LCAN350-38-X
Copper Lug - One-Hole, Narrow Tongue, Standard Barrel

DRAWING NO / CAD FILE
LCAN350-38-CUST

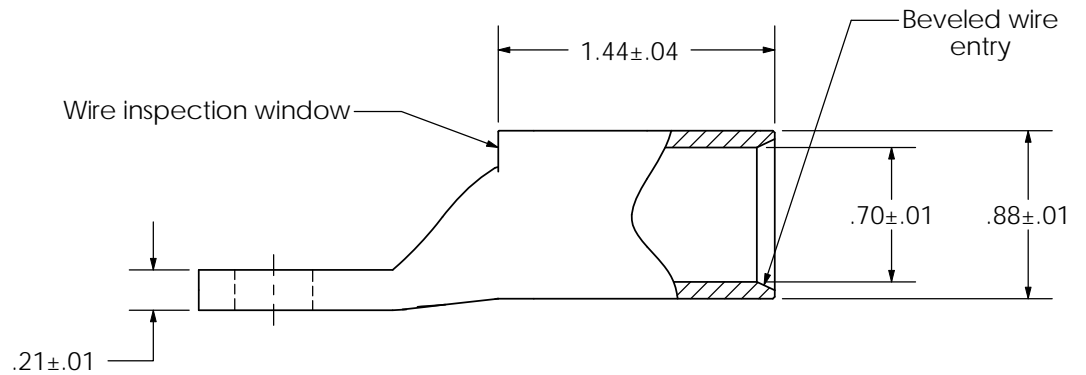
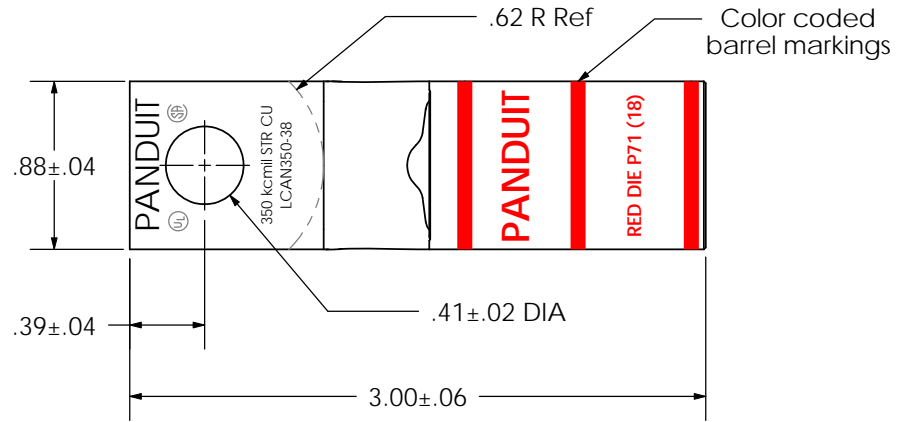
REV	DATE	BY	CHK	DESCRIPTION	ECN	SCALE	DRAWING NO / CAD FILE
01	1/11	JHNU	JHNU	REVISED OVERALL LENGTH: WAS 2.98 REVISED TONGUE THICKNESS: WAS .17		N/A	LCAN350-38-CUST
